Office Action Summary	Application No. 10/585,454	Applicant(s) WOEHRLE ET AL.	
	Examiner MICHAEL MCDUFFIE	Art Unit 3632

The following correspondence is a non-final Office Action for application # 10/585,454, entitled: DRIVE FOR ADJUSTING MOTOR VEHICLE SEATS, filed on 08/04/2006.

Figure 1

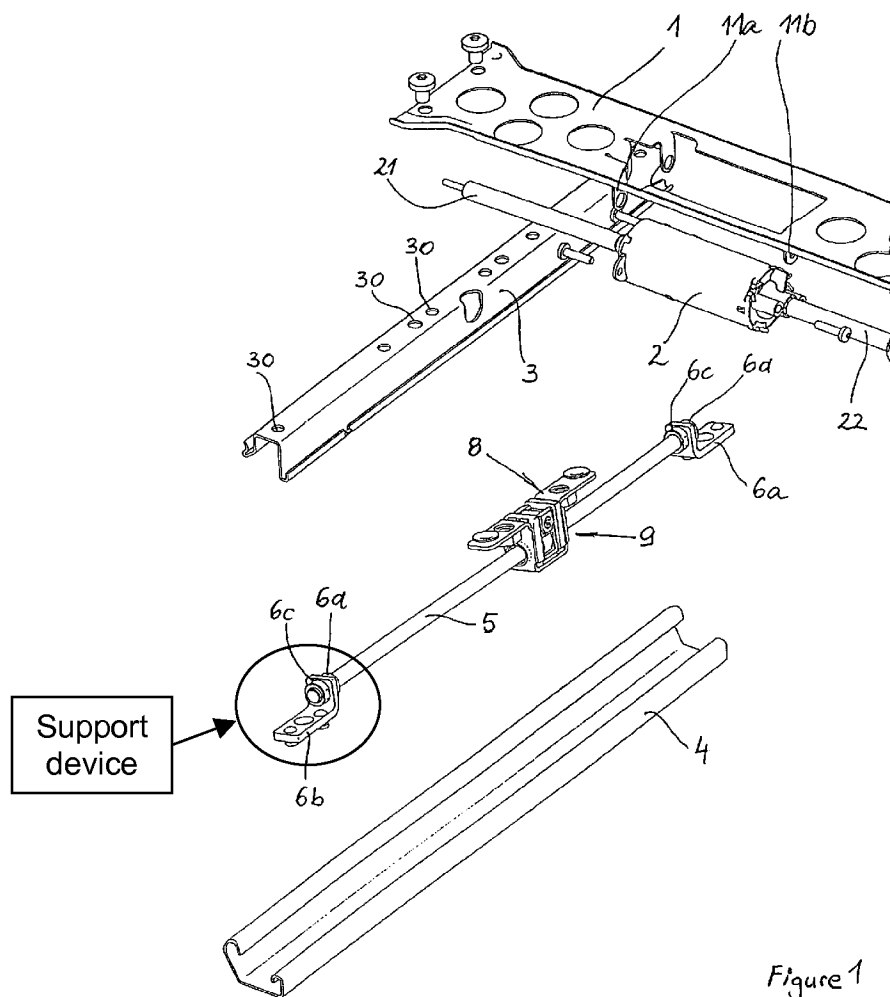
Regarding claim 1, Taubmann discloses a drive having a spindle **5** that is attached to first **4** of two rails **3**, **4** that are adjustable relative to one another by means of support device (as shown in Fig. 1 below) located on at least one end of spindle **5**, and having gear mechanism **9** driven by motor **2**, which is arranged on second rail **3**. Taubmann fails to teach where at least one support device has a trough-shaped outer support surface in which one end of the spindle is seated in a fixed manner. The Examiner notes that the spindle's attachment to the support device is merely an alternative method of fastening the elements together. The claim would have been obvious because the substitution of one known element for another would have yielded predictable results to one of ordinary skill in the art at the time of the invention.

With regards to claim 2, Taubmann teaches the drive, characterized by two such support devices (see Fig. 1 below) being provided, whereby one of such support devices **60** serves to hold one of two ends of spindle **5** in each instance.

With regards to claims 23-25, Taubmann teaches the drive, characterized by spindle **5** that is seated firmly on support device(s) forming a pre-assembled module together with lower rail **4** and upper rail **3**, where the lower rail **4** being releasably connected with support device(s), and further characterized by lower rail **4** and support devices being connected with one another in a form-fit manner (as shown in Fig. 1).

Figure 2

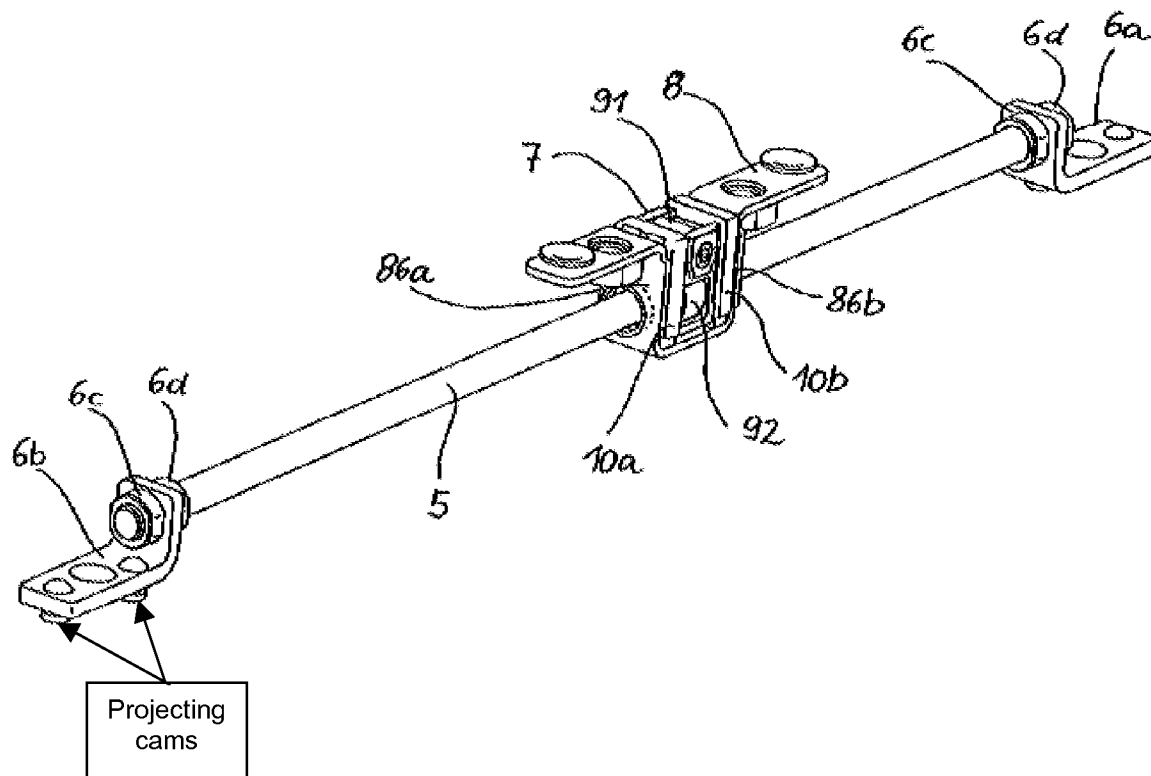
With regards to claims 15 and 16, Taubmann teaches the drive, characterized by support device having no less than one projecting cam (as shown in Fig. 2 below) on its lower support surface for engaging into corresponding opening of first rail **4**, and where the two cams are spaced apart from one another when seen in the longitudinal axis to spindle **5**.

Figure 15

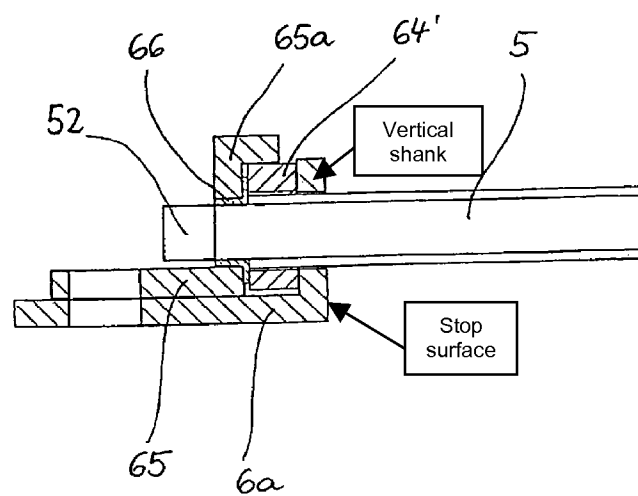
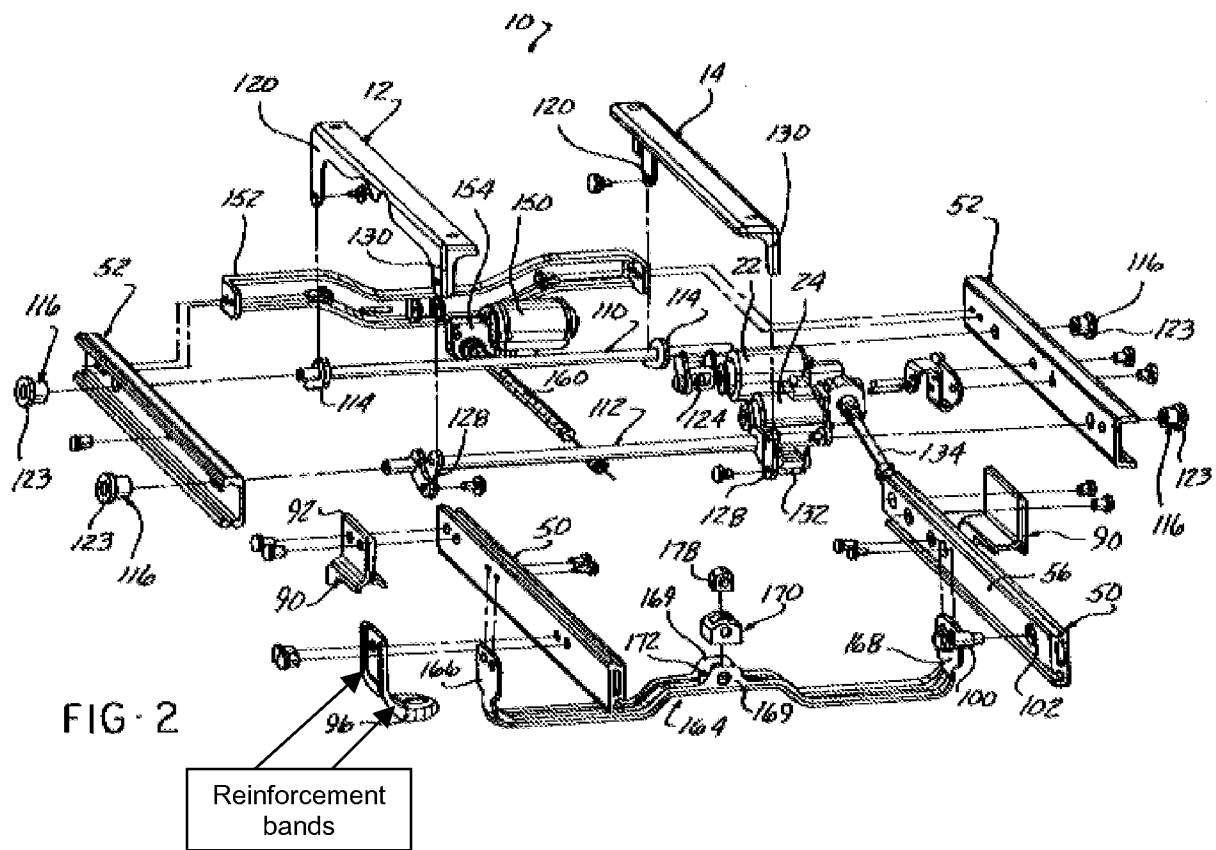
Regarding claim 20, Taubmann discloses the drive, characterized by solid, block-like vertical shank (see Fig. 15 below) of support device having outer stop surface (as shown in Fig. 15 below) for gear mechanism **9** that can move on spindle **5**, which surface runs orthogonally to horizontal shank **6a**.
